Model Error Resolution Document <i>Complete only applicable items.</i>		QA: QA
			Page 1 of 2

1. Document Number:	MDL-WIS-PA-000005	2. Revision/Addendum:	Rev 00 and AD 01	3. ERD:	ERD 05
4. Title:	Total System Performance Assessment Model/Analysis for the License Application				
5. No. of Pages Attached:	24

This Error Resolution Document (ERD) is provided to update the *Total System Performance Assessment for the License Application* (TSPA-LA) documents, including Rev 00, the addendum (AD 01), ERD 02 and ERD 04, to correct issues identified in the following condition reports (CRs). The corrections identified are necessary to add clarity and strengthen the discussion within the suite of TSPA-LA documents. There are no impacts on results or conclusions due to the clarifications and text revisions from the CRs listed below. CR 12543, however, will have an impact on the results from the TSPA-LA localized corrosion initiation analysis (Appendix O), but will have no effect on the overall model conclusions that are based on the calculation of repository performance.

Figure O-3. Average Delta E for Percolation Subregion 3, CSNF, for 300 Epistemic Realizations

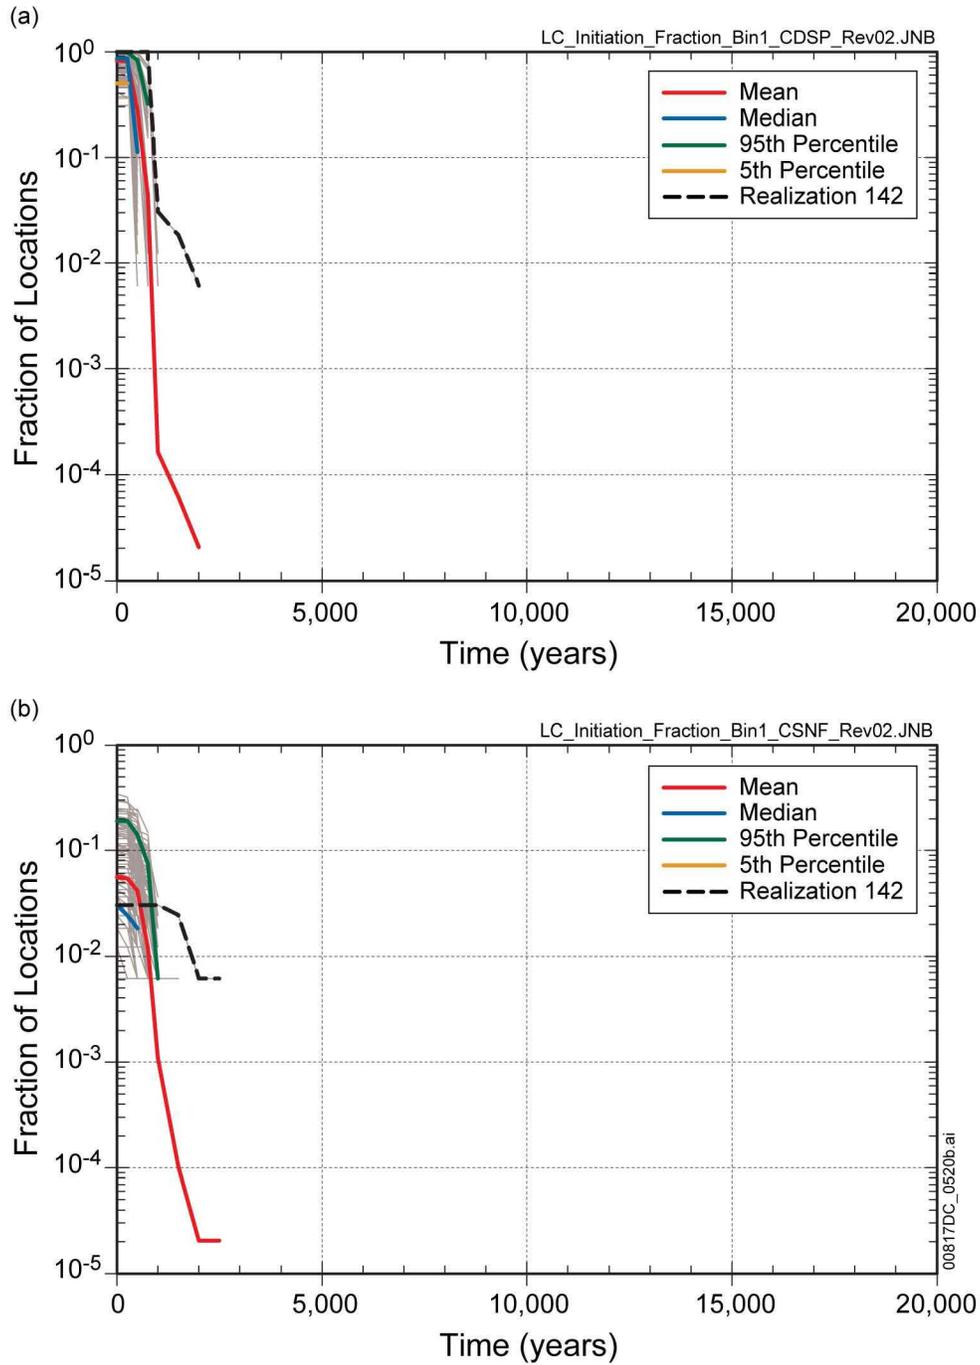
As mentioned previously, only realization 142 has conditions favorable for localized corrosion initiation persisting beyond a few thousand years. This persistence is due to the combination of uncertain parameters in this realization. The coefficients in Equation O-1 and Equation O-2 are correlated within each equation, but the uncertainty terms and the coefficients are not correlated between the two equations. This allows for sampling the combination of large negative values for a_o and ε_{rrev} , and large positive values for c_o and ε_{corr} . Also, the algorithm for applying uncertainty in the chemistry model essentially fixes the $[Cl^-]/[NO_3^-]$ ratio as an epistemic parameter (Section 6.3.4.3.2). These features of this analysis imply that seven of the epistemic uncertain parameters essentially combine to give a constant value for each realization.

The combined value of the uncertain parameters in Equation O-3 for realization 142 is -936 mV, which is the tenth lowest of the 300 realizations. This large negative value means that the other conditions must change dramatically for the ΔE to become positive. Specifically, the temperature must cool down significantly and the $[Cl^-]$ and $[NO_3^-]$ must both become smaller. It takes a long time in realization 142 to overcome the large negative value indicated by Equation O-3.

Figure O-1. Fraction of Locations with the Potential for Localized Corrosion Initiation as a Function of Drip Shield Failure Time: (a) Bin1, CDSP; (b) Bin1, CSNF; (c) Bin2, CDSP; (d) Bin2, CSNF; (e) Bin3, CDSP; (f) Bin3, CSNF; (g) Bin4, CDSP; (h) Bin4, CSNF; (i) Bin5, CDSP; and (j) Bin5, CSNF

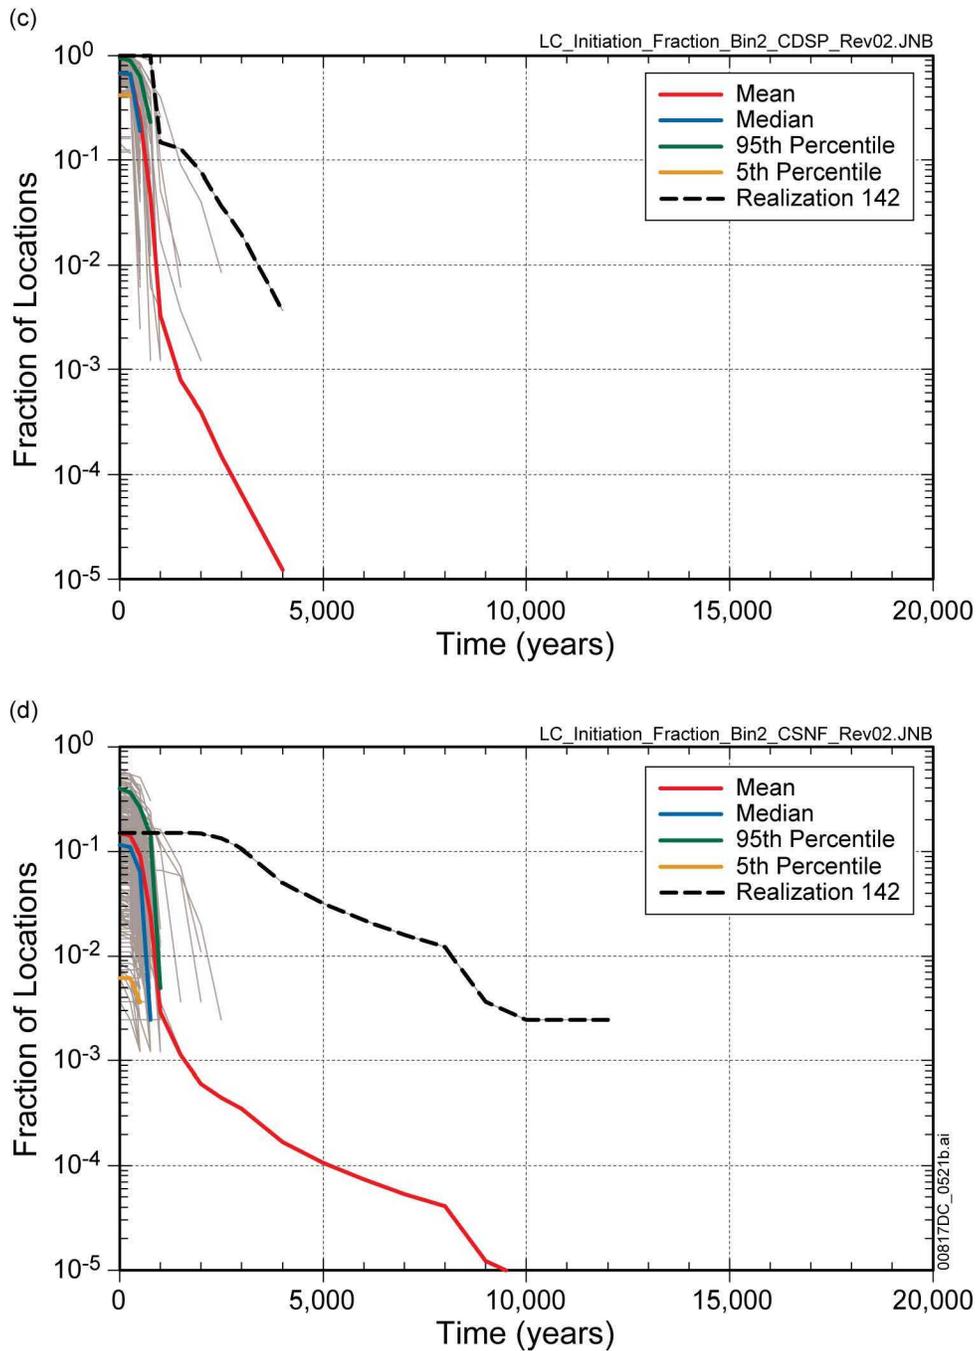
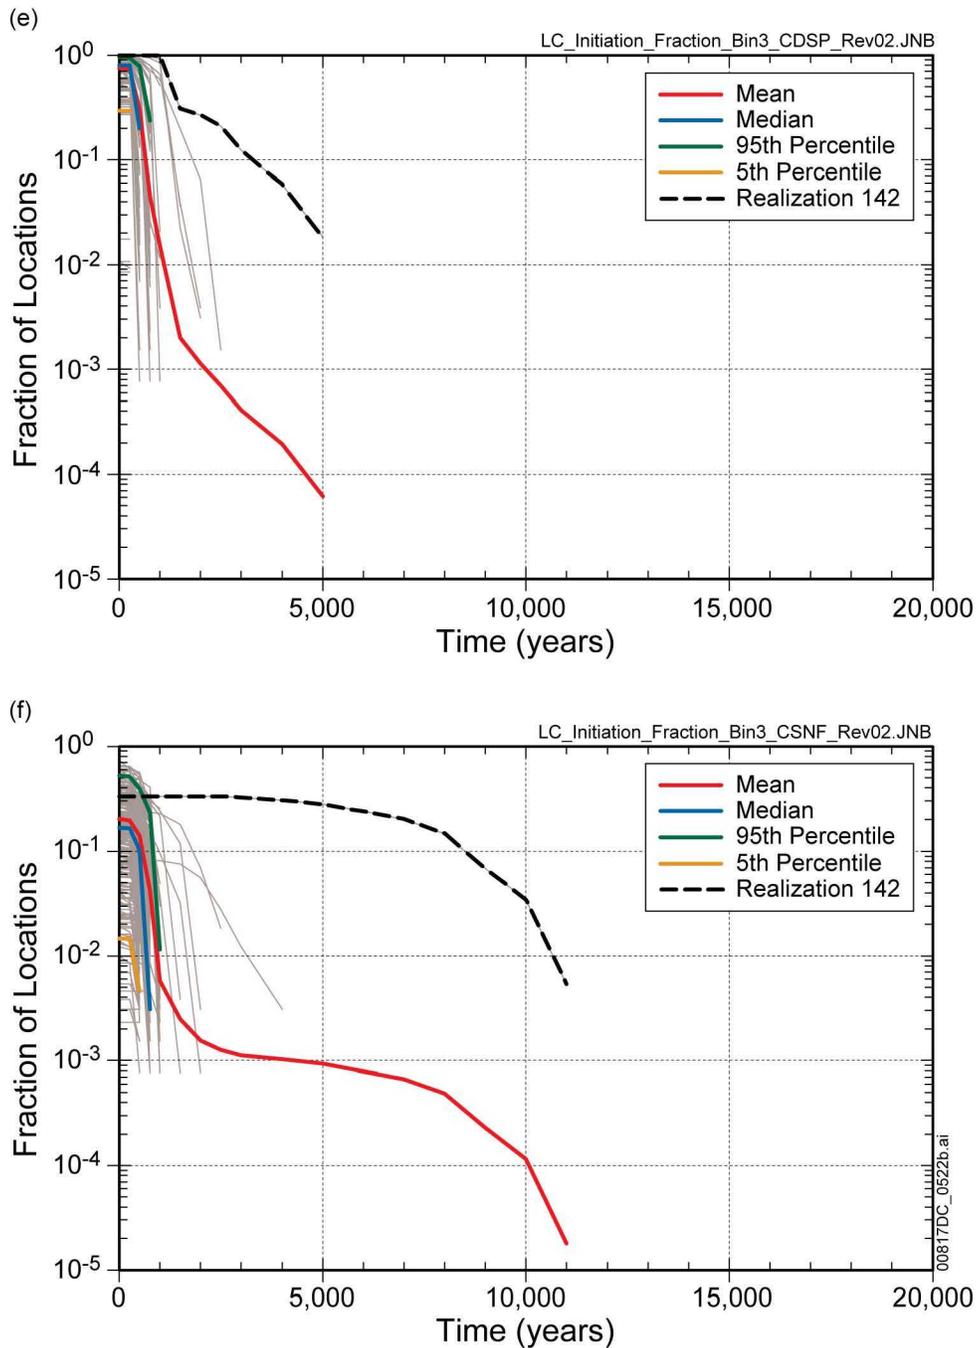
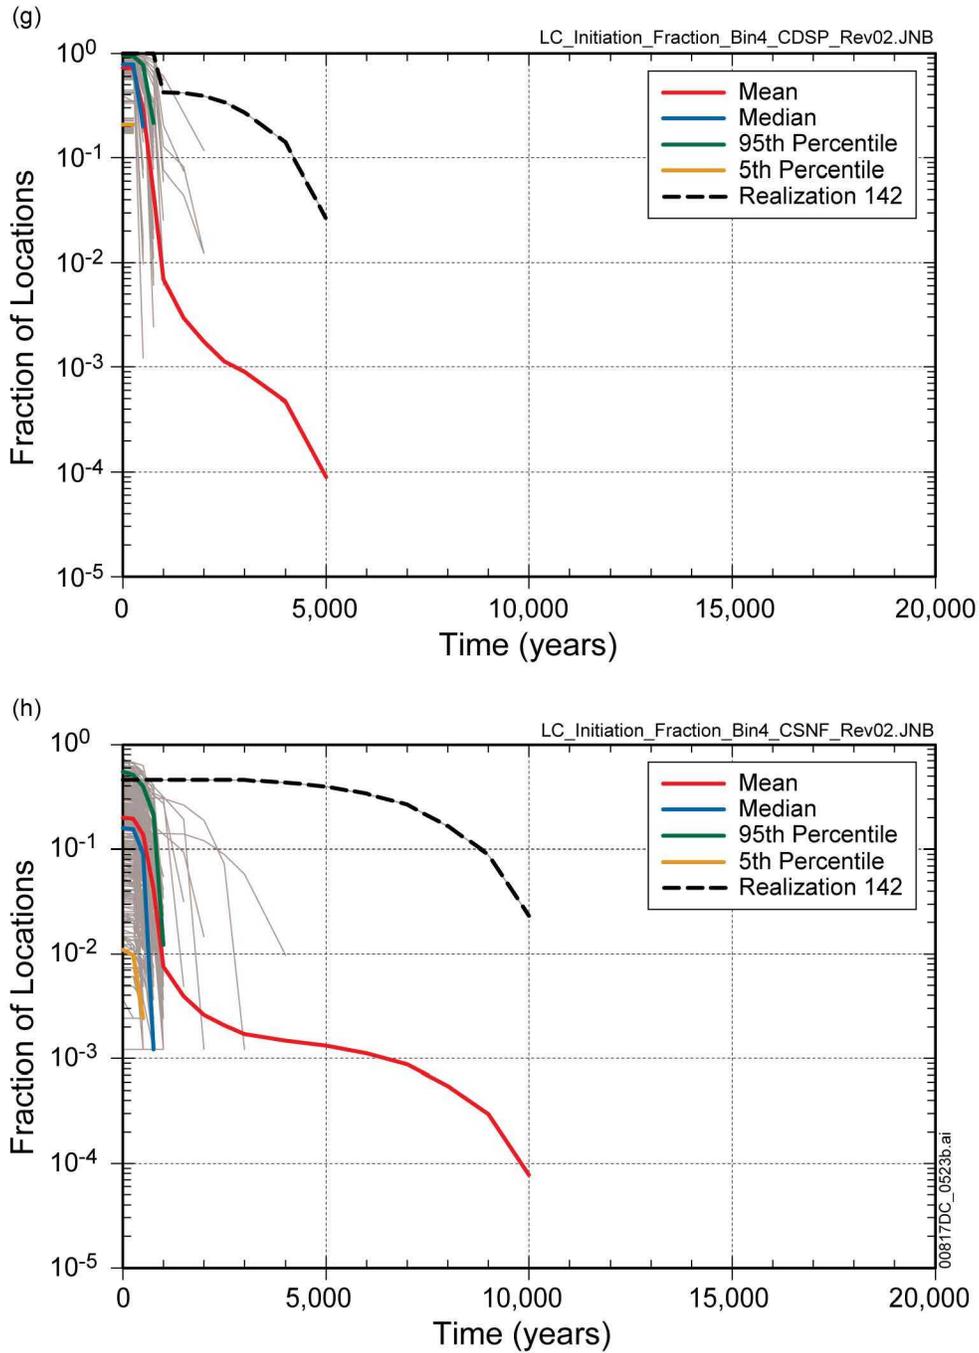
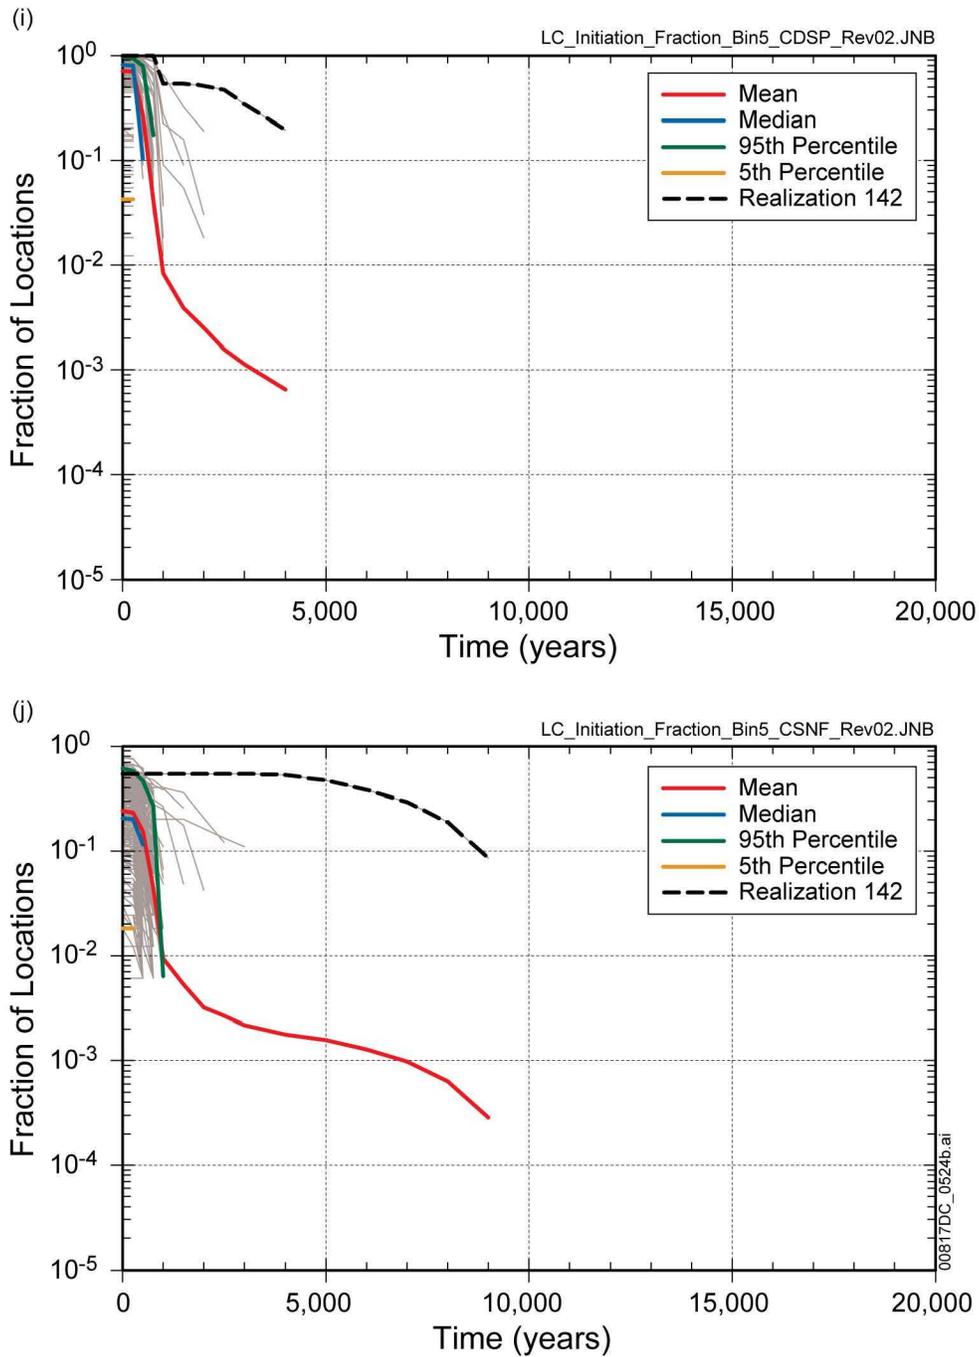
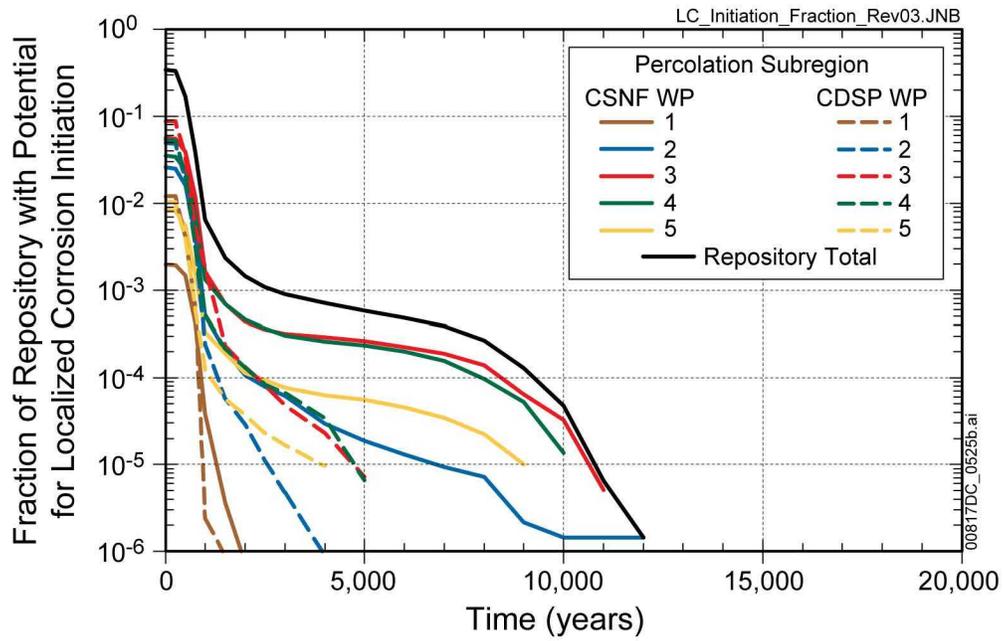
A new analysis has been completed with the appropriate implementation of localized corrosion being initiated from the occurrence of salt separation and the output DTN updated (MO0709TSPALOCO.000 [DIRS 185808]). This ERD updates the discussion presented in Appendix O of the parent document (Attachment 1), which is based on TSPA-LA Model v5.000 (output DTN: MO0709TSPAREGS.000 [DIRS 182976]) with results from the new analysis and dose histories from TSPA-LA v5.005 (output DTN: MO0710ADTSPAWO.000 [DIRS 183752]). The original dose analysis evaluating the impact of localized corrosion in the Seismic Ground Motion Modeling Case for 10,000 years (DTN: MO0708FREQCALC.000 [DIRS 183006]) presented in Section 7.3.2 of the parent document has also been updated (Attachment 2) with the corrected localized corrosion model results and TSPA-LA v5.005 dose histories from output DTN: MO0710ADTSPAWO.000 [DIRS 183752]. Attachment 2 contains a replacement for TSPA-LA Figure 7.3.2-17; however no modification to the text was required. Attachment 3 contains areas in the document which should be revised to reflect the new localized corrosion DTN.

ATTACHMENT 1—REPLACE APPENDIX O (CR 12543)**01. INTRODUCTION**

In the table of contents, update the figure caption of Figures O-1 and O-2.

The fraction of locations with the potential for localized corrosion initiation is highest for DS failures within the first few hundred years because both initiation processes are affected by the hot, low relative humidity conditions. As the repository initially heats up and dries out, the relative humidity drops below the salt separation threshold at many locations. The hot and relatively dry conditions also give the lowest ΔE values. These first few hundred years are also the time when Stage 2 drift-wall condensation occurs at every CDSP WP location, which gives many seeping locations. Therefore, most CDSP locations have the potential for localized corrosion initiation if the DS fails within the first few hundred years. It should be noted that the

In general, bins 3, 4, and 5 have higher fractions of localized corrosion because they have more locations with seepage. Before about 1,000 years, the CDSP WPs have a higher fraction of locations with potential localized corrosion initiation. This is due to the Stage 2 drift-wall condensation at every CDSP WP location. After Stage 2 ends at around 1,000-years, drift seepage dominates over drift-wall condensation and CSNF WPs have a higher incidence of localized corrosion initiation mainly because CSNF WPs have higher temperatures than CDSP WPs. Also, shown on Figure O-1 is the dominant effect of the single epistemic realization number 142, which is the only realization to have any nodes with localized corrosion after a few thousand years.

Figure O-2. Fraction of Locations in Each Percolation Subregion with the Potential for Localized Corrosion Initiation after the Drip Shield Fails as a Function of Drip Shield Failure Time

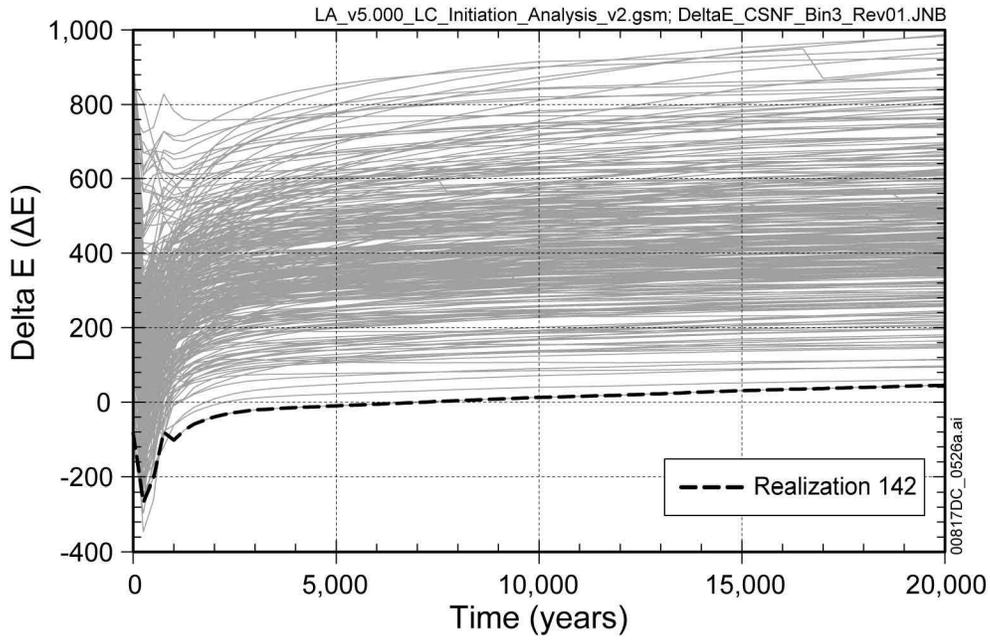
Figure O-2 shows the average fraction of all WPs that could potentially experience localized corrosion, computed by multiplying each of the mean curves on Figure O-1 by its respective bin fraction (0.05, 0.25, 0.40, 0.25, and 0.05) and its WP type fraction (3416/11629 for CDSP WP and 8213/11629 for CSNF WP). There are more CSNF WPs and they are hotter so CSNF WPs comprise a larger fraction of the total number of WPs that could experience localized corrosion. The repository total curve shows the mean fraction of WPs with potential for localized corrosion for the entire repository. The average fraction of WPs on which localized corrosion may potentially initiate peaks at about 0.34 for the first few hundred years after closure when the repository is hot, and highly concentrated solutions exist on the WP surface. Of the 0.34 fraction, about 0.1 is from the corrosion potential only and the remainder is from the chloride rich brine resulting from salt separation (or both). After a few thousand years, the fraction of WPs with the potential for localized corrosion initiation decreases to below 10^{-3} .

Figure 7.3.2-17. Expected Annual Dose Over 10,000 Years from Seismic Ground Motion Events that Result in Drip Shield Plate Failure

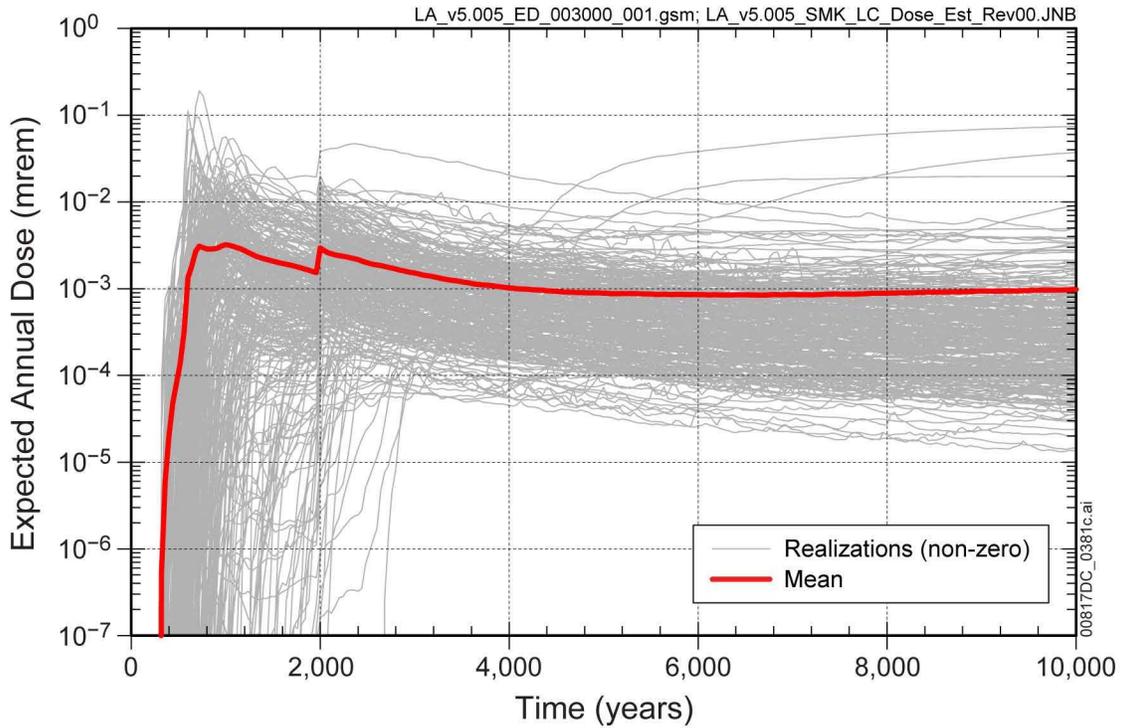
ATTACHMENT 2—REPLACE FIGURE 7.3.2-17 ON PAGE F7.3.2-17

Source: Output DTNs: MO0710ADTSPAWO.000 [DIRS 183752]; and MO0709TSPALOCO.000 [DIRS 185808].
 NOTE: This figure has been updated to use dose data from v5.005 of the TSPA-LA Model.
